Office Action Summary

09/743,726

GAMBALE ET AL.

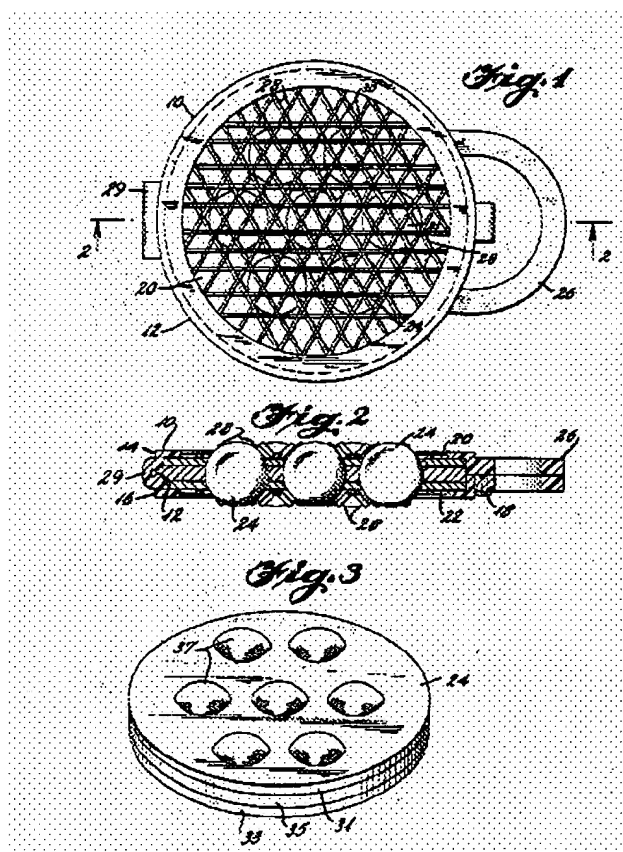
Claim 1 is rejected under 35 U.S.C. 102(b) as being anticipated by Reed, U.S. Patent No. 3,443,561. The cited patent discloses a pellet containing a therapeutic agent; a flexible, implantable body having a hollow interior configured to receive and retain the pellet within the interior after the body has been implanted within tissue.

Figures 1-3 show a pellet containing a therapeutic agent; a flexible, implantable body having a hollow interior configured to receive and retain the pellet within the interior after the body has been implanted within tissue.

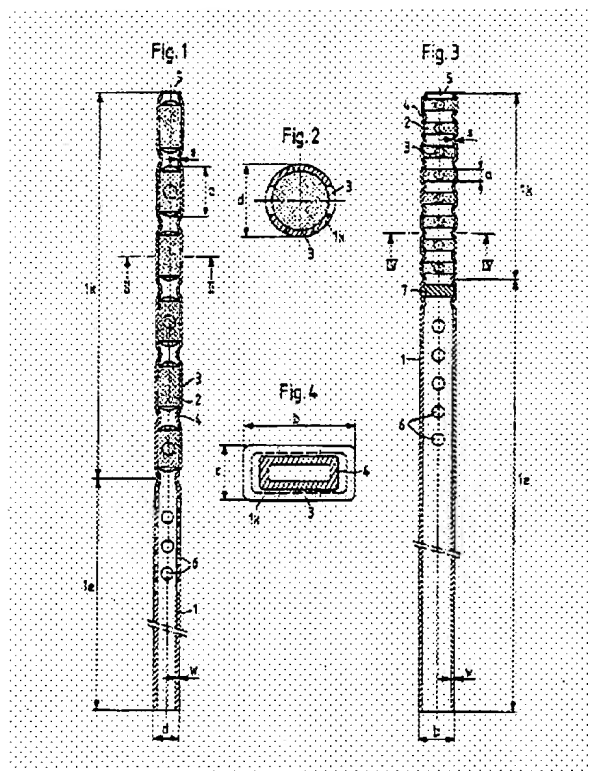
Claim 5 is rejected under 35 U.S.C. 102(b) as being anticipated by Billeter, et al., U.S. Patent No. 4,731,054. The cited patent discloses a pellet containing a therapeutic agent; a flexible and implantable body defining an interior sized to accept the pellet and having proximal and distal ends; wherein, the proximal end is sized to accept the pellet and the body further having at least one opening sized to permit bodily fluid to enter the interior but sized to prevent the pellet from exiting the interior (see figures 1-4 below).

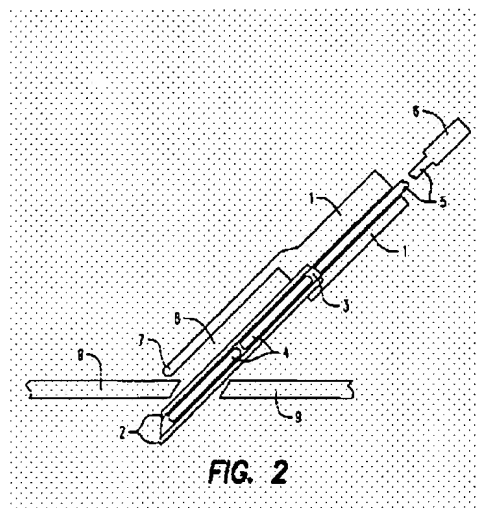
In figures 1 and 2, Pryor, et al., shows an agent delivery system comprising a helical spring in combination with an insertion device. Moreover, it is the examiner's opinion, that it is well known in the art to use obturators with cutting edges to cut skin surfaces in order to facilitate the insertion of delivery systems into the body.
